KEYSTONE XL PIPELINE PROJECT

0478-SD-P4-419.8-420.1-1

| KEYSTONE XL PIPELINE PROJECT PIPELINE ROUTE VARIATION FORM | | | |

KEYSTONE XL PROJECT
RV-0478-01 CL CHANGES

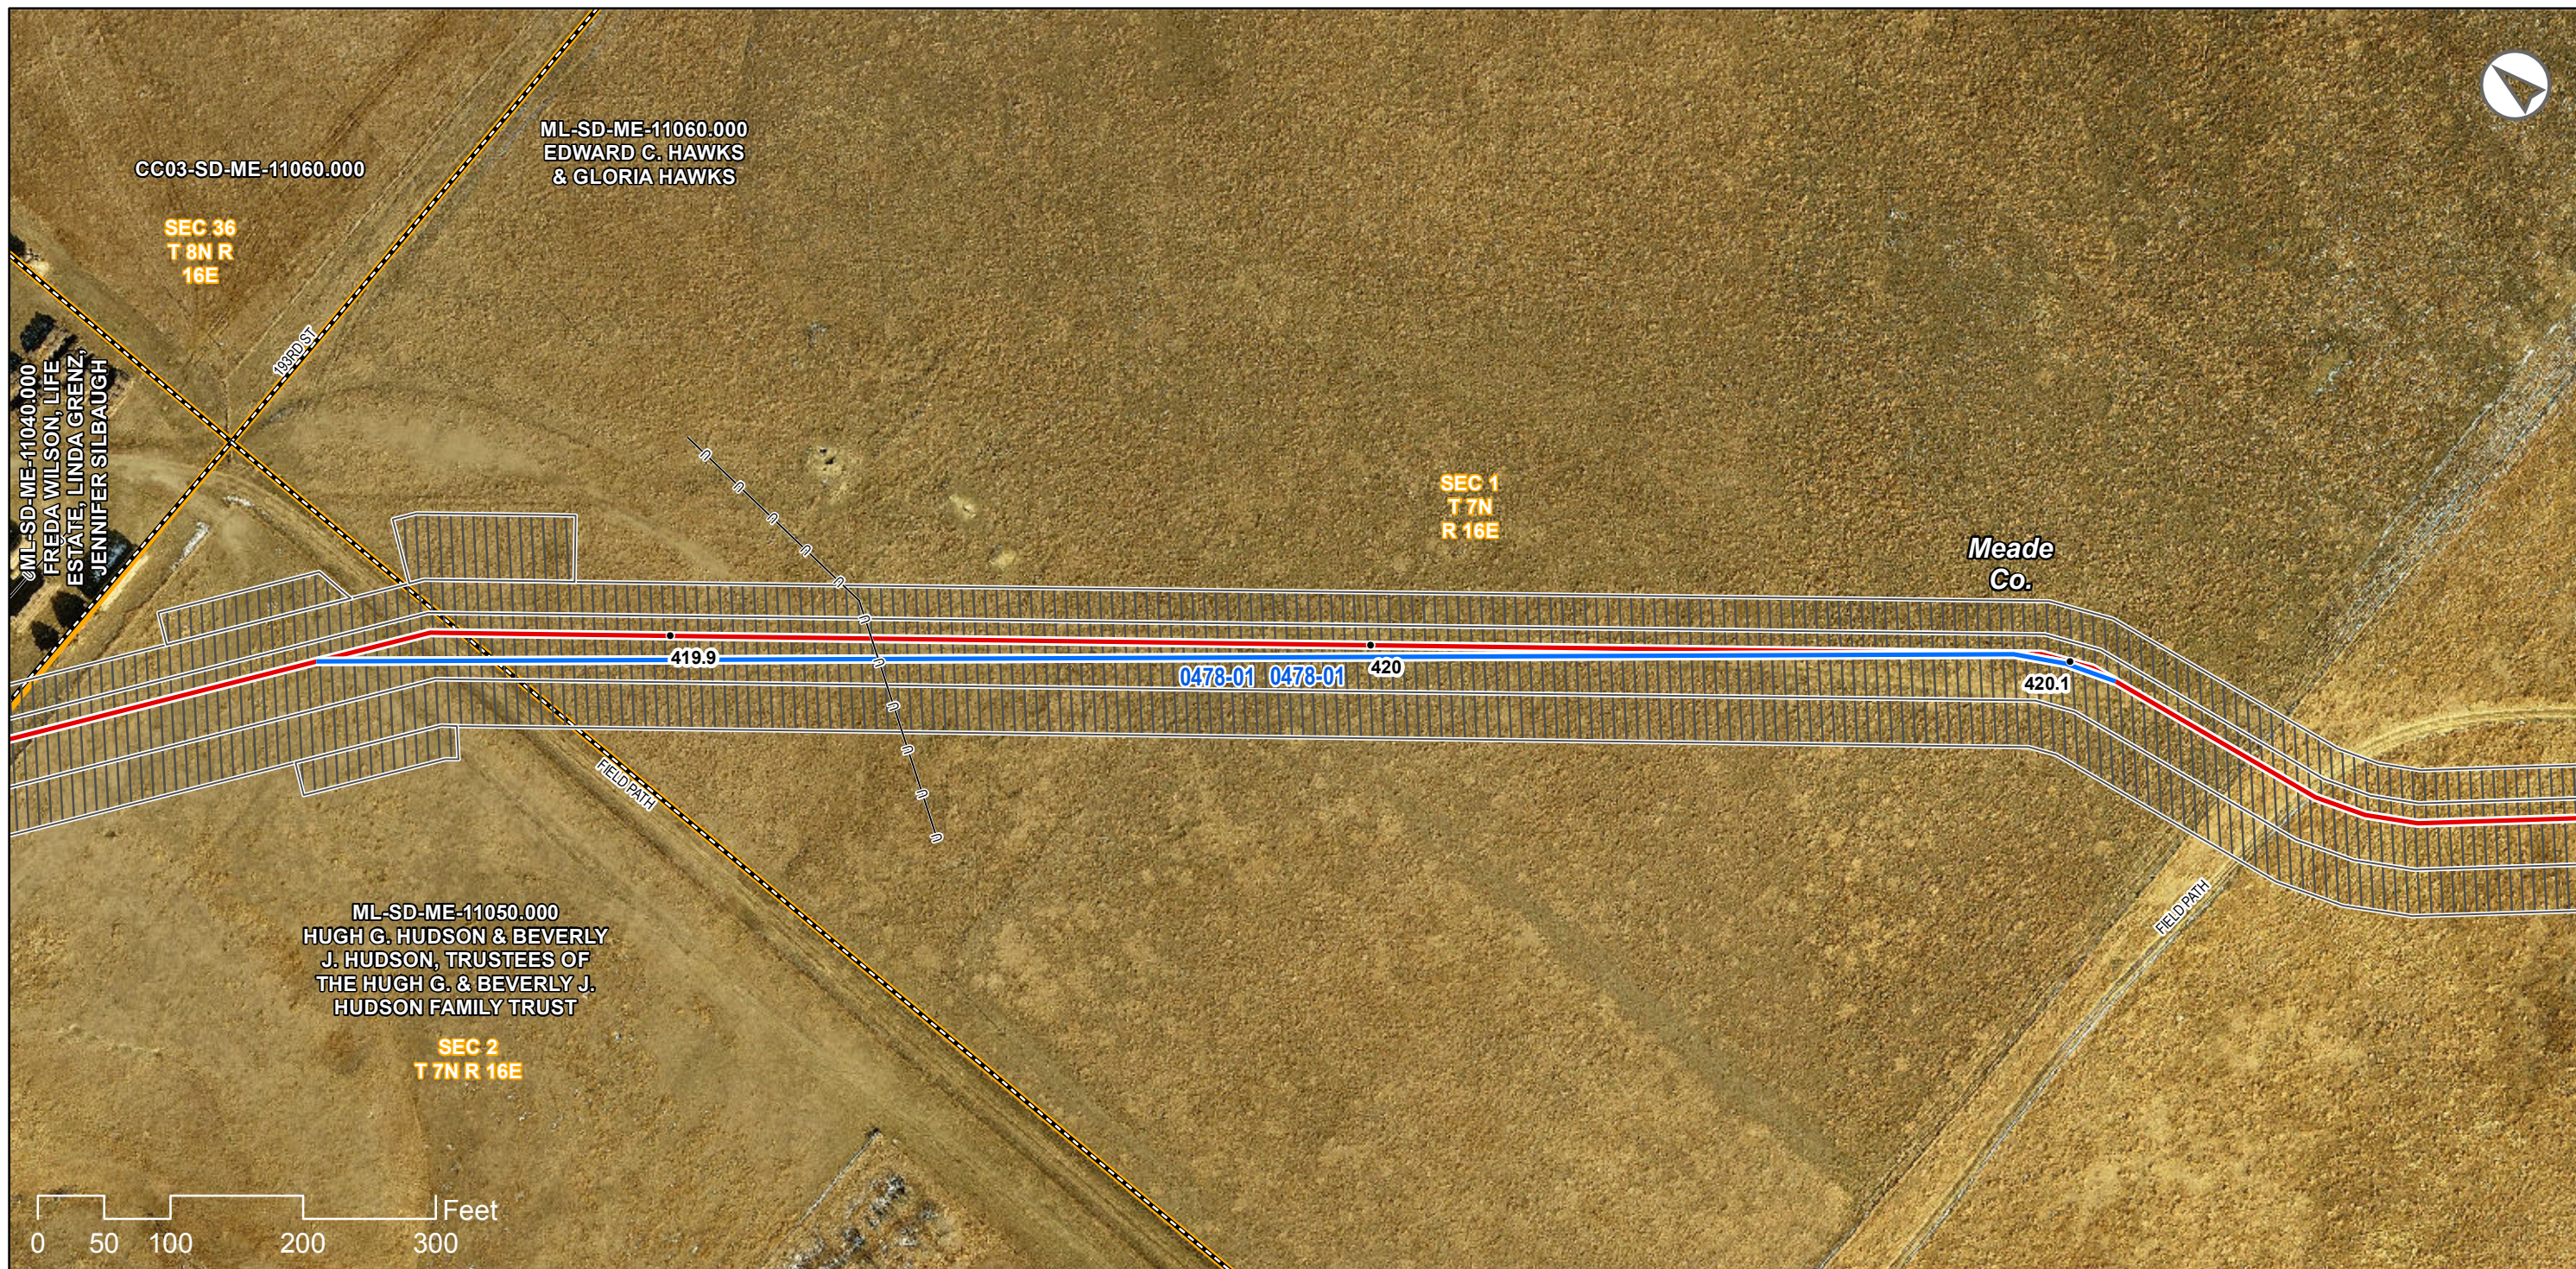
| KEYSTONE XL PIPELINE PROJECT PIPELINE ROUTE VARIATION FORM | | | |
|---|--|---|-------------------------|
| 3 | REASON FOR ROUTE VARIATION (Please include reason for route variation): <div style="border: 1px solid black; padding: 5px; min-height: 80px;"> The primary reason for this reroute is to shift PI out of road crossing (field road, CAR 166). This reroute has been proposed by Engineering based on 90% alignment sheet review and has been civil surveyed. </div> | | |
| | DETAIL ROUTE VARIATION (Please describe route variation in detail): <div style="border: 1px solid black; padding: 5px; min-height: 80px;"> The proposed reroute begins near MP 419.85 and deviates from the current CL ~14". It continues along a straight southeast path for ~1,279 ft. Then it turns a couple of times for a total distance of ~80 ft. to rejoin the current CL near MP 420.11. </div> | | |
